Application No.	Applicant(a)
	Application No.	Applicant(s)
Notice of Allowability	10/521,541	JO, KOANG-HO
	Examiner	Art Unit
	Derek D. Knight	3681
The MAILING DATE of this communication app All claims being allowable, PROSECUTION ON THE MERITS IS herewith (or previously mailed), a Notice of Allowance (PTOL-85 NOTICE OF ALLOWABILITY IS NOT A GRANT OF PATENT F of the Office or upon petition by the applicant. See 37 CFR 1.31	rears on the cover sheet with 5 (OR REMAINS) CLOSED in to 6) or other appropriate commun RIGHTS. This application is su	his application. If not included ication will be mailed in due course. THIS

EXAMINER'S AMENDMENT

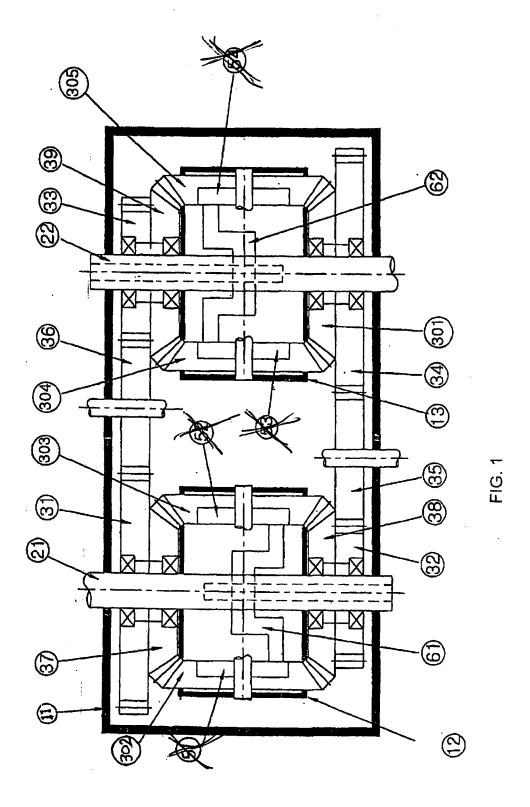
In Fig. 1 of the drawings: Reference numbers 51, 52, 53, and 54 should be removed.

In Fig. 3 of the drawings: Reference number 26 should be removed from the lower figure, or the leader should be moved to point to the correct feature.
